10/046,379

BLOWER NOZZLE WITH VARIABLE VELOCITY OUTPUT

Petition to Withdraw Holding of Abandonment

AMENDMENT UNDER 37 C.F.R. 1.111

Figure 1

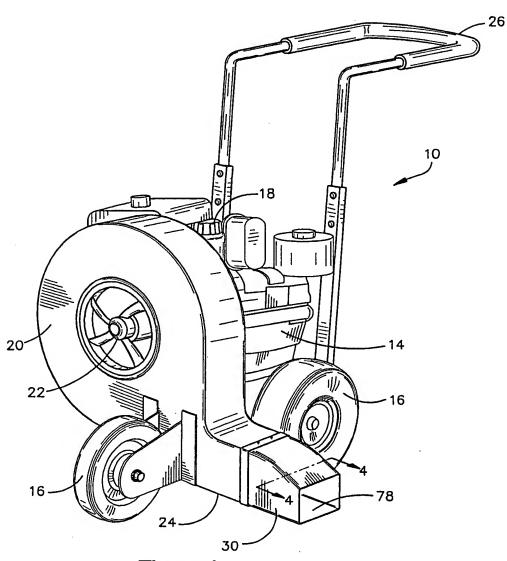
The attached sheets of formal drawings replace the original informal drawings. The attached sheets of drawings also includes changes in that reference numbers identifying the parts identified in the written description have been added.

The drawings currently stand rejected because they fail to include reference numbers identifying the parts of the invention as described in the written description. Applicants submit herewith the attached replacement sheets of formal drawings to replace the original informal drawings. The replacement drawings includes changes in that reference numbers identifying the parts identified in the written description have been added. Applicants submit that no new matter has been added by these amendments.
